1.5.x Customer Release Notes

SELENIA®
Dimensions®

MAN-11492 Revision 001

March 2024

3.1.5 Enhancements to Multi-Vendor Display of Mammography Images

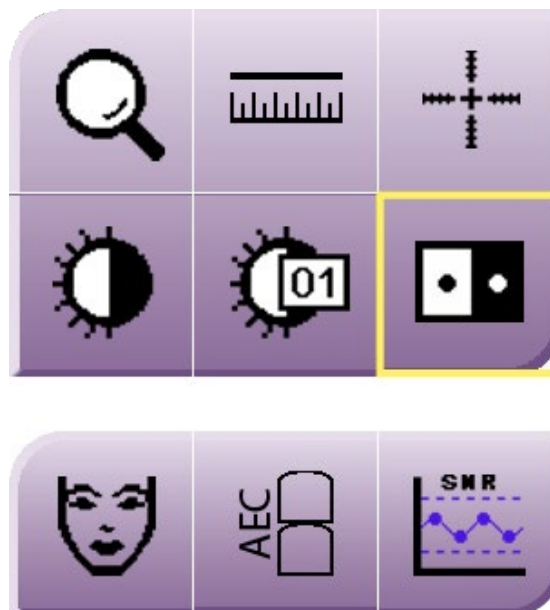
A number of changes were made to fine tune the display of multi-vendor mammography images on the acquisition workstation as specified by the *IHE Mammography Image Display* profile.

- VOI LUT sequences are preferred over simple window/level settings when displaying images that contain both sets;
- Minor issues displaying Fuji, Fischer and legacy GE images have been addressed;
- Secondary capture images will now display consistently on the acquisition workstation;
- Image thumbnails will be displayed correctly and will represent the corresponding image accurately;
- The acquisition workstation can now export multi-vendor images to media.

3.2.3 Markings and Annotations

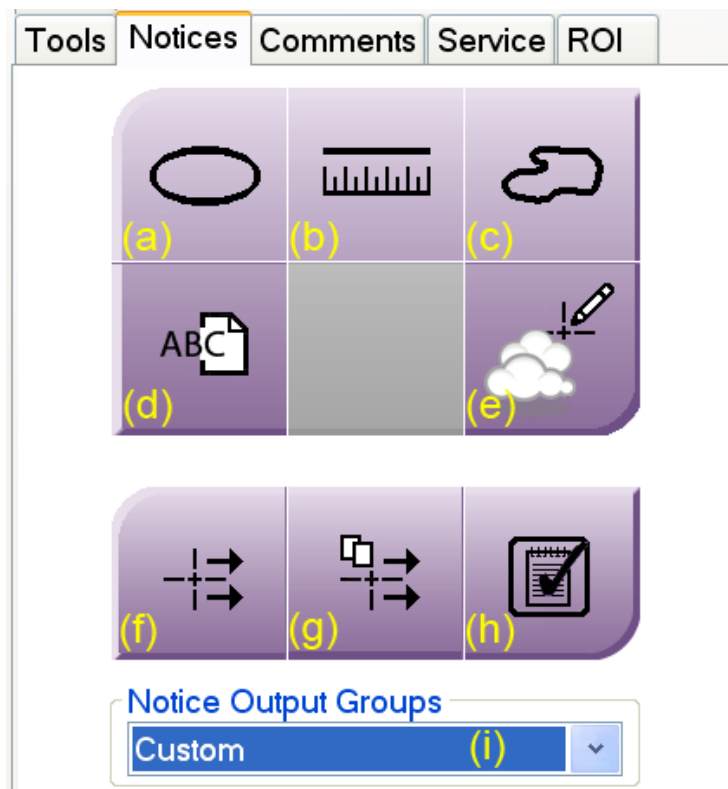
The *Notices* tab was revised to represent the updated and enhanced markings and annotations functionality. The followings are descriptions of the available functions in this tab:

- a. Draw an ellipse marking with annotation on the image;
- b. Draw a measurement on the image;
- c. Create a freehand marking and annotation on an image;
- d. Add a text note to the image;
- e. Show or hide markings and annotations;
- f. Send the markings and annotations of the selected (displayed) image to the selected destination;
- g. Send the markings and annotations of all images in the opened study to the selected destination;
- h. Mark the procedure that contains new notices as viewed;
- i. Select the destination to send the markings and annotations.

3.3.2 System Dose Calibration and Verification

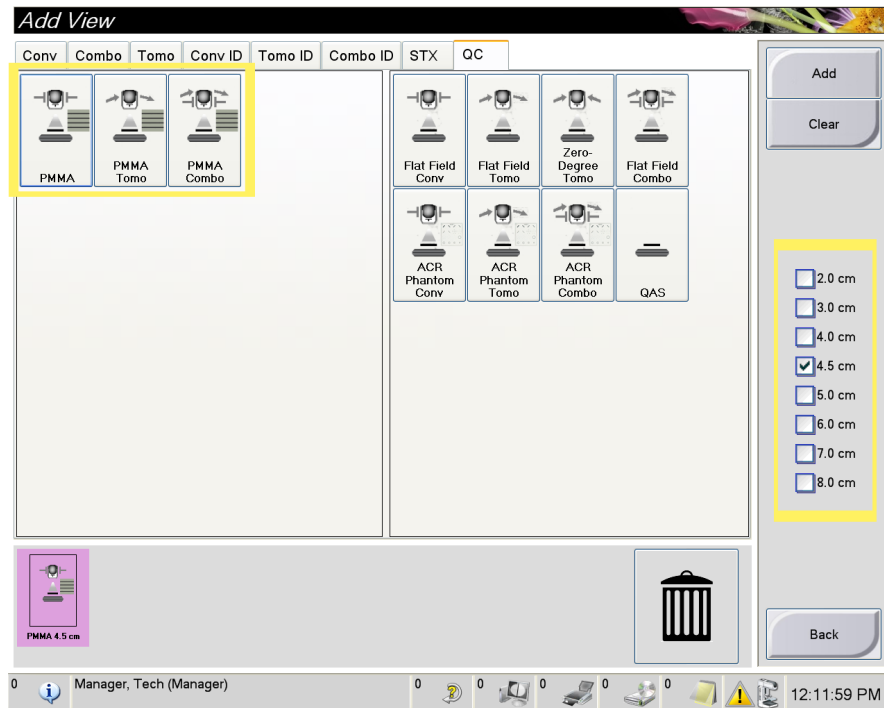
The system now supports dose calibration by a field service engineer using PMMA phantom material. Specialized views have been added in the *QC* tab of the *Add View* form to allow for dose verification using variable thickness of PMMA phantom material.

3.3.4 AEC Compensation Steps

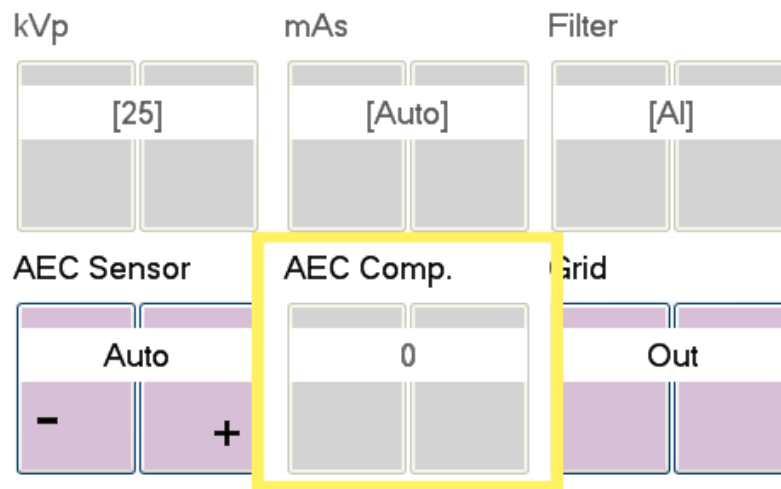
The AEC compensation function should not be used during the acquisition of tomosynthesis images. Thus, the AEC compensation steps were disabled in the *Tomo* acquisition tab of the user interface.

The AEC compensation function is applicable to the acquisition of conventional FFDM images, only. Changing the AEC compensation steps in the *Conv* acquisition tab of the user interface will only affect the AEC function during the acquisition of conventional FFDM images, even when a combination procedure is acquired.

3.4.1 MPPS Enhancement

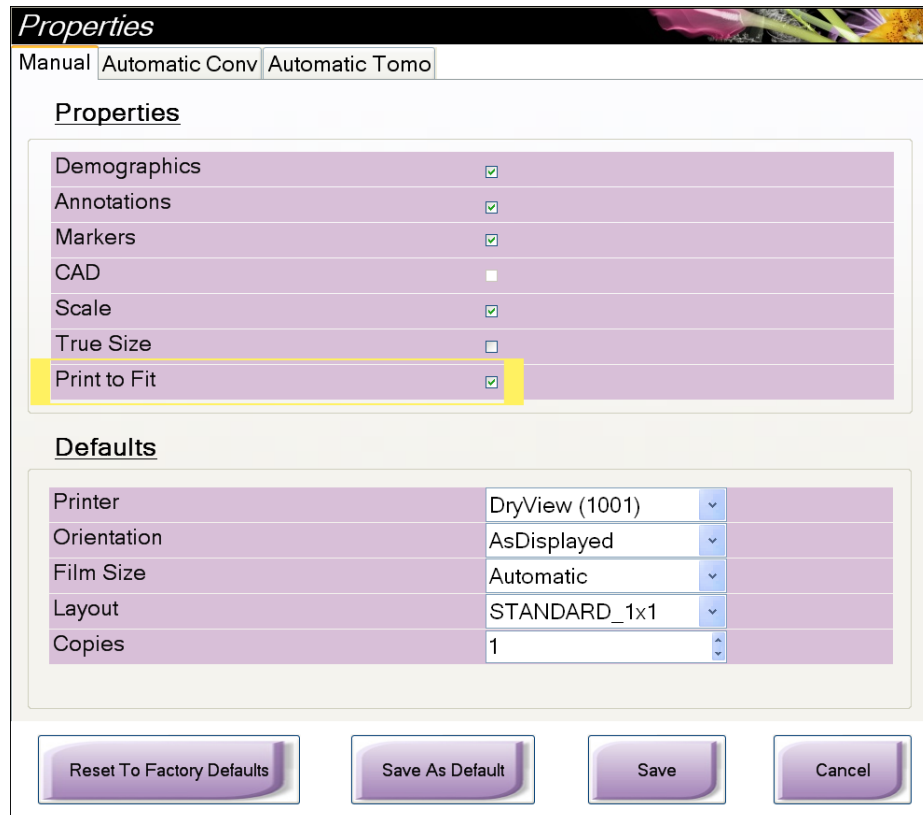
For those systems that are configured to use MPPS messaging, the acquisition workstation may be configured to bypass certain MPPS restrictions and allow the user to add or edit a view, or change the disposition of a study, i.e. from "*Discontinued*" to "*Completed*" or "*In progress*".

3.5.2 Edit View Enhancements

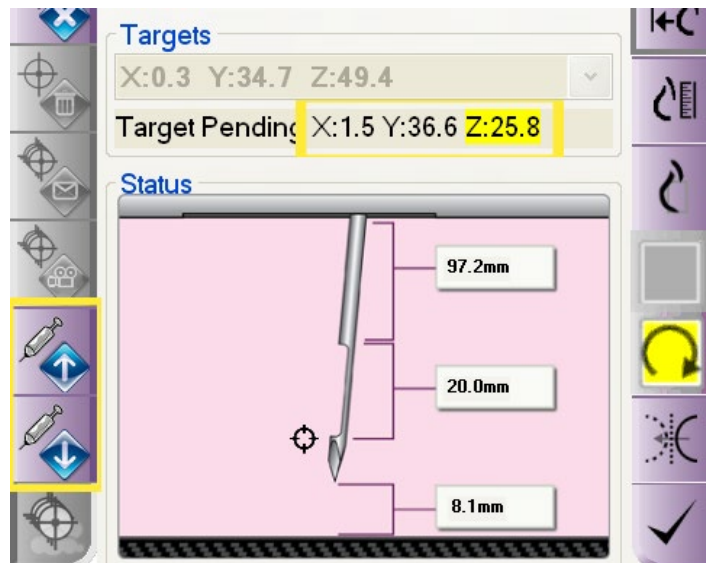
The *Edit View* functionality has been extended to the biopsy specific views. Biopsy views can be edited by the user with the restriction that a single view, i.e. scout, will only be edited to another single view and double views, i.e. stereopair, will only be edited to another double view.

After editing a biopsy specific view, any targets previously created in that view are retained and remain valid targets in the corresponding target set.
